CITY OF ENCINITAS ENGINEERING DEPARTMENT

WIRO PARK PLAYGROUND EQUIPMENT REPLACEMENT

Community Meeting

May 28, 2026

WIRO PARK – PLAYGROUND – Comments Received

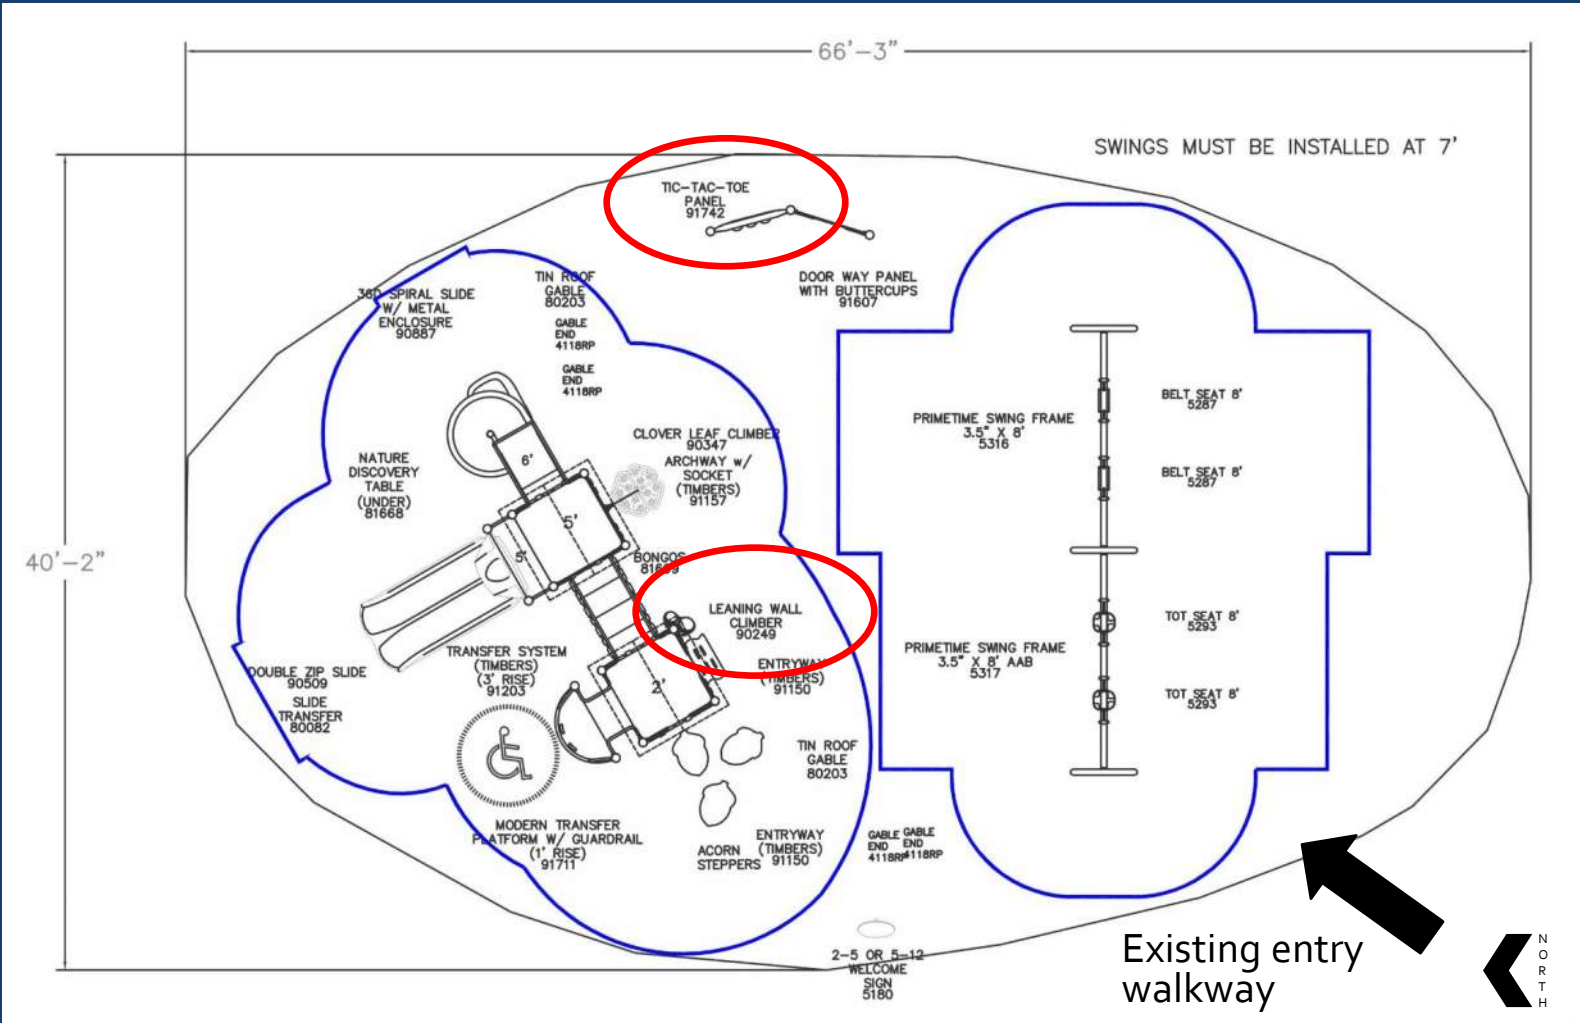
The small Flower Spinner Half Panel and the Door Way Panel w/Buttercups - because the surface will be rubber or spongy - could some other jungle gym style bars be placed here?

For the Flower Wall, is it possible to put in the rock climbing wall or climbing thing? If not because of the fall zone, what about tic-tac-toe? Just something active that can be used rather than a pretty wall.

- There is not space to add a climbing element without conflicting with the safety zone of the swings and the structure. These freestanding panels don't have safety zones, which allows them to fit within the space.

- Yes, the flower spinner panel wall was replaced with the tic-tac-toe panel.
